## **Arlington Zoning Board of Appeals**

Date: Tuesday, November 9, 2021

### **MEMORANDUM**

RE: Docket 3668 – 125-127 Webster St; Special Permit under Zoning Bylaw Section 8.1.3

Dimensional and Parking Information
For Applications to the Zoning Board of Appeals

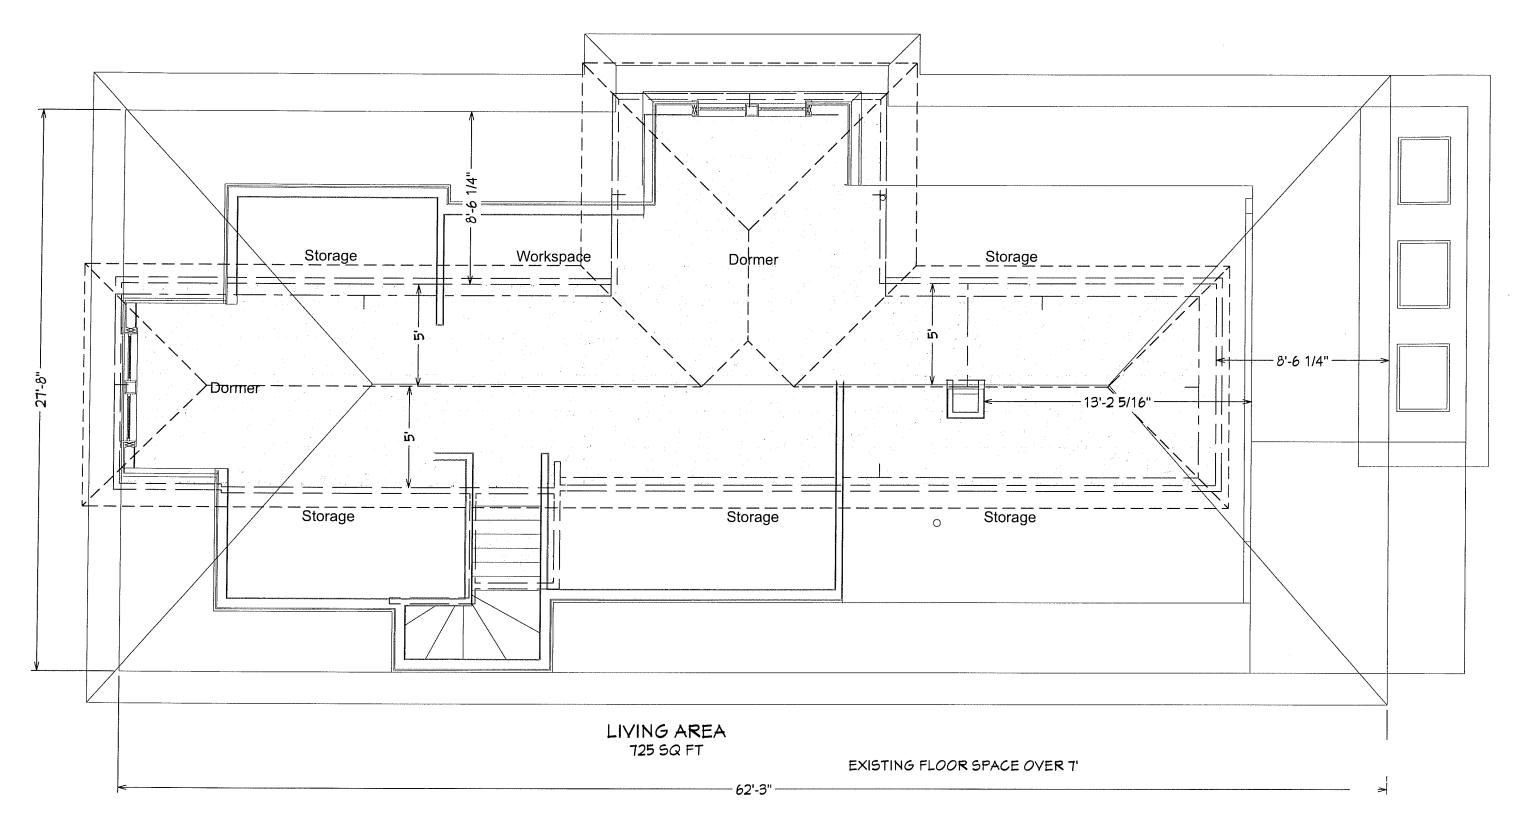
- The applicant states that the attic area currently has 1,084 square feet greater than 7 feet in height, and that converting the top level to a third floor with 882 square feet would increase the total square footage of the structure from 5,741 to 5,773 square feet (+32 square feet). The applicant has not provided dimensional details on the current height of the attic area, however given that the proposed height of the structure is not increasing under the proposal and based on standard geometrical assumptions it is unlikely that the applicant's Open Space/Gross Floor Area Information worksheet is correct.

- Information on the provided worksheets is not consistent with notes on dimensional details provided on the two sets of floor plans.
- The applicant has completed forms for a Special Permit, however the request to create the nonconforming third floor cannot be accommodated through the granting of a Special Permit.

- Updated Dimensional and Parking Information and Open Space/Gross Floor Area Information worksheets.
- Updated drawings and elevations that communication dimensional details consistent with those provided on the worksheets noted above.
